U.S. EPR Rod Ejection Accident Methodology

ANP-10286NP-A
Revision 0

**UNITED STATES
NUCLEAR REGULATORY COMMISSION
WASHINGTON, D.C. 20555-0001**

**SUBJECT: FINAL SAFETY EVALUATION REPORT REGARDING ANP-10286P,
"U.S. EPR ROD EJECTION ACCIDENT METHODOLOGY TOPICAL REPORT"**

Figure 2 – Details of Analysis Methodology (0 - ~ 5 sec.)

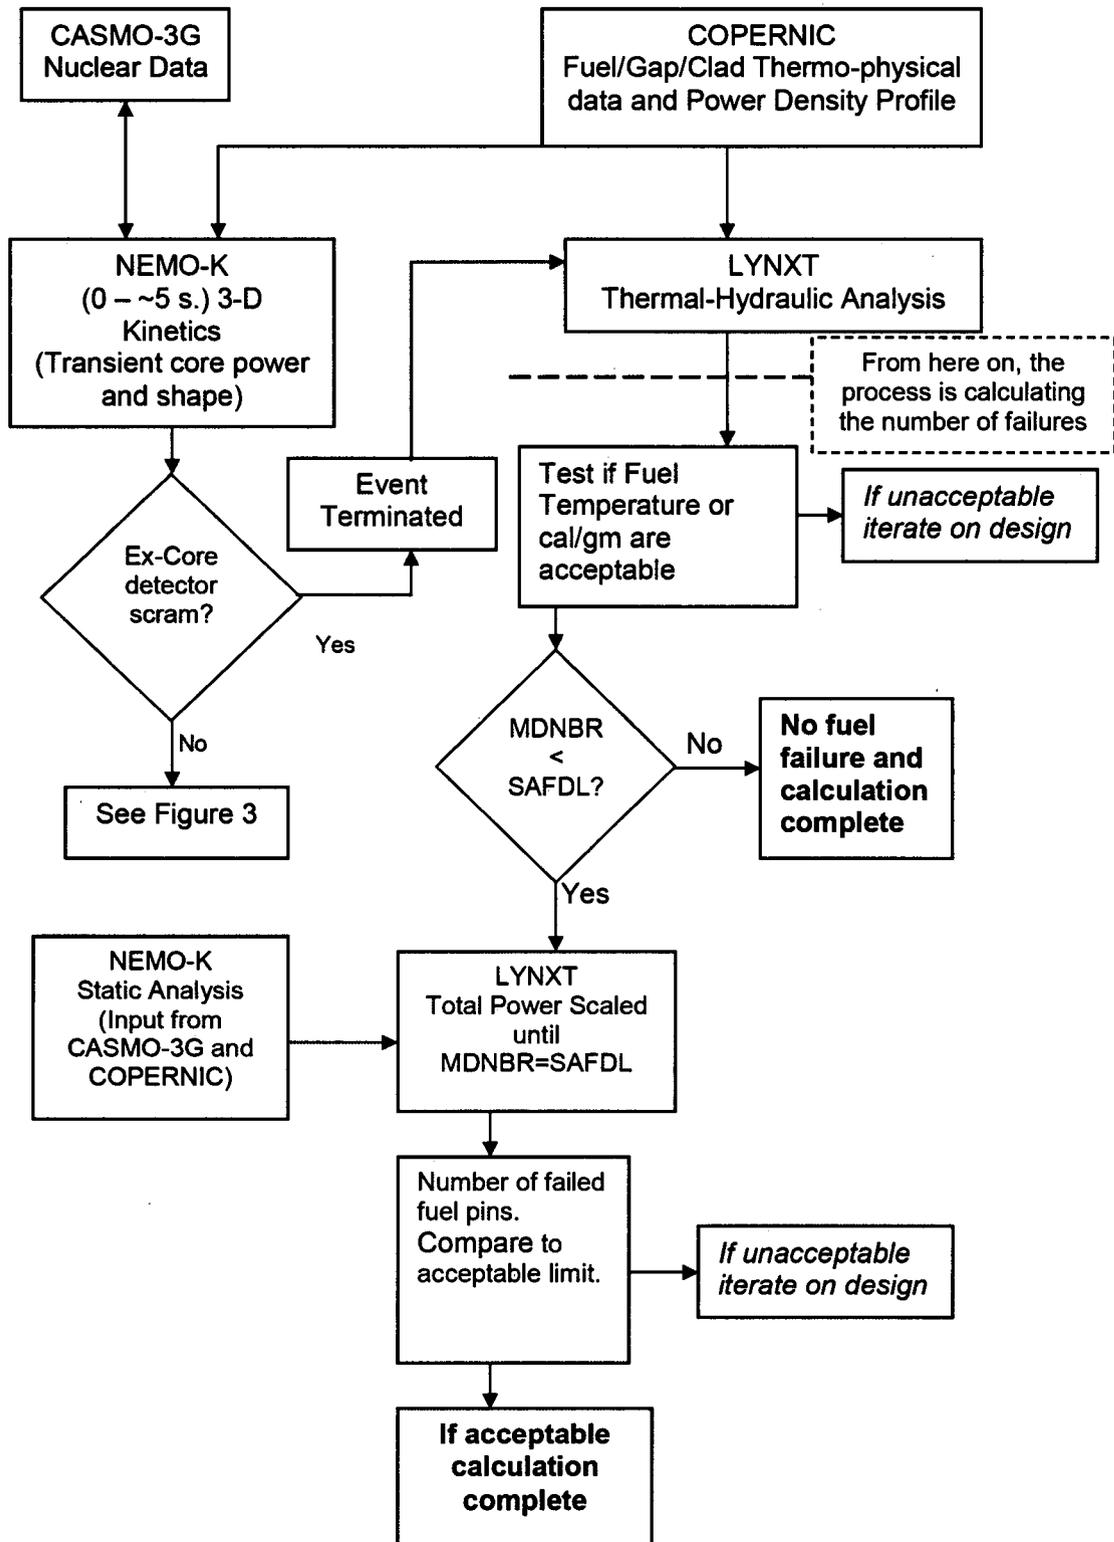
AREVA noted on Figure 2 that the box with "Ex-core detecto" is missing some text.

Figure 3 – Details of Analysis Methodology (greater than approximately 5 sec.)

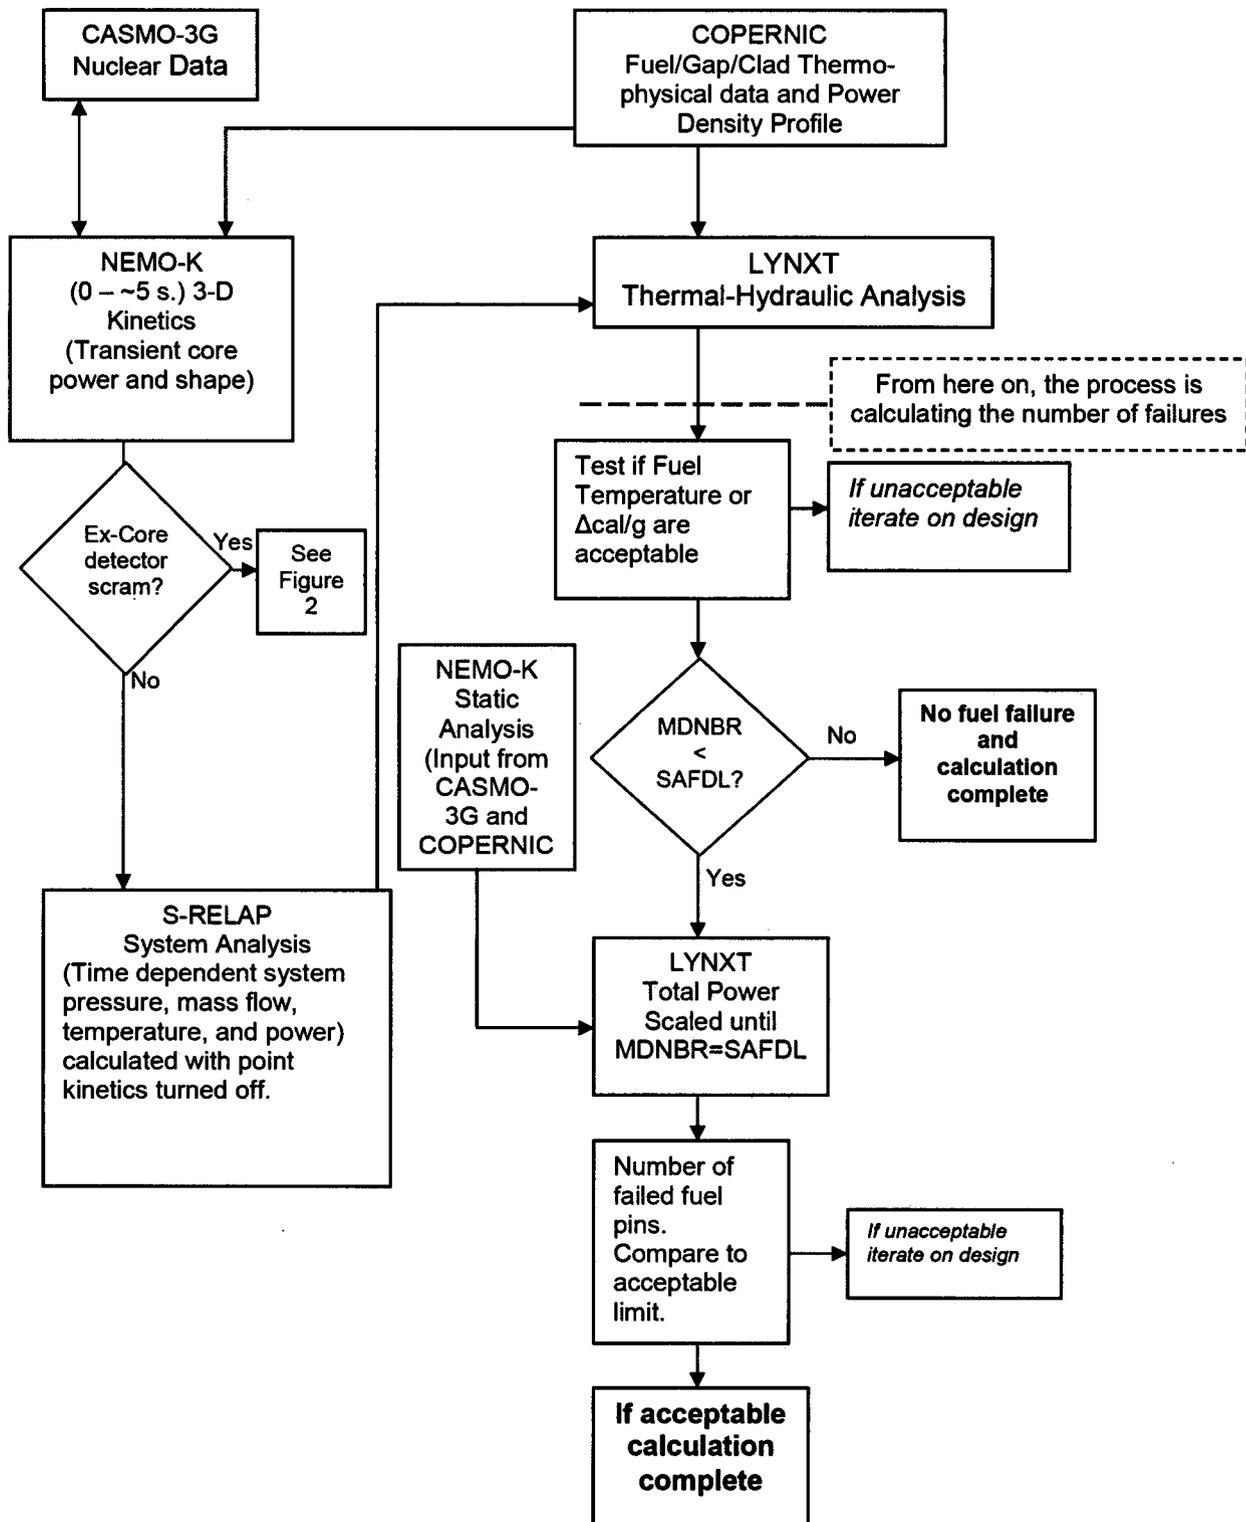
AREVA noted on Figure 3 that S-REALP should be S-RELAP5 in boxes and that the words "No scram" in the NEMO-K box were incorrect.

Figure 6-1 Scram Position Versus Drop Time

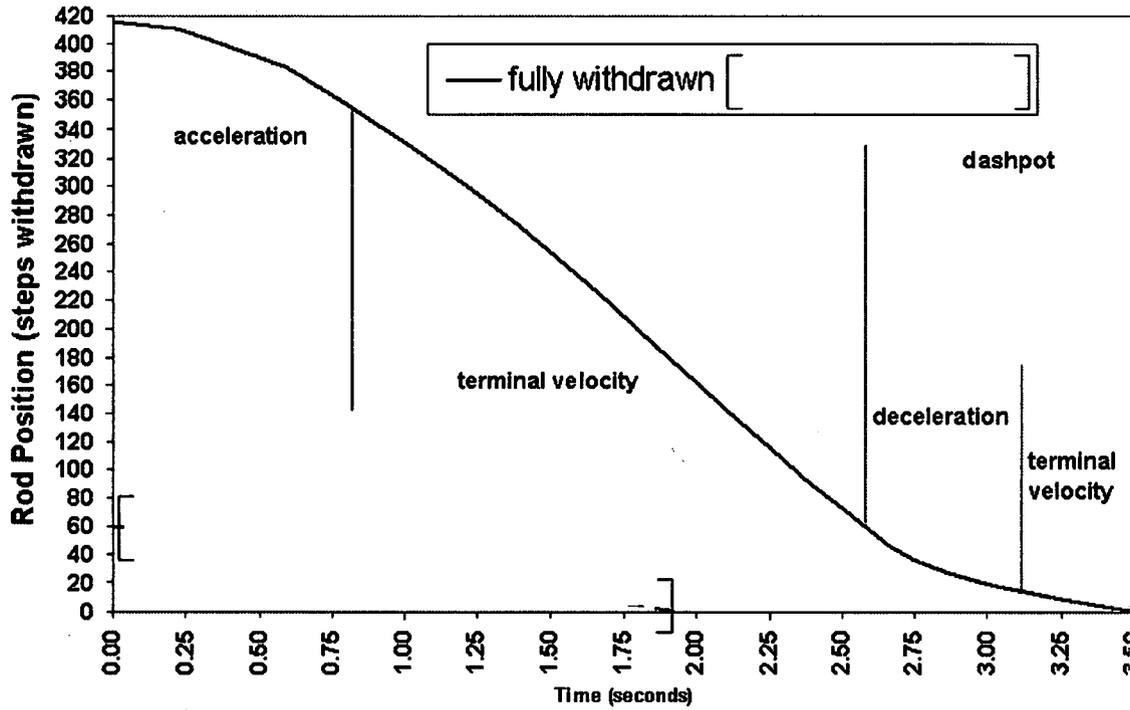
AREVA noted in Section 3.4.1 that the statement "It takes approximately 1.5 seconds . . ." should be consistent with Figure 6-1.
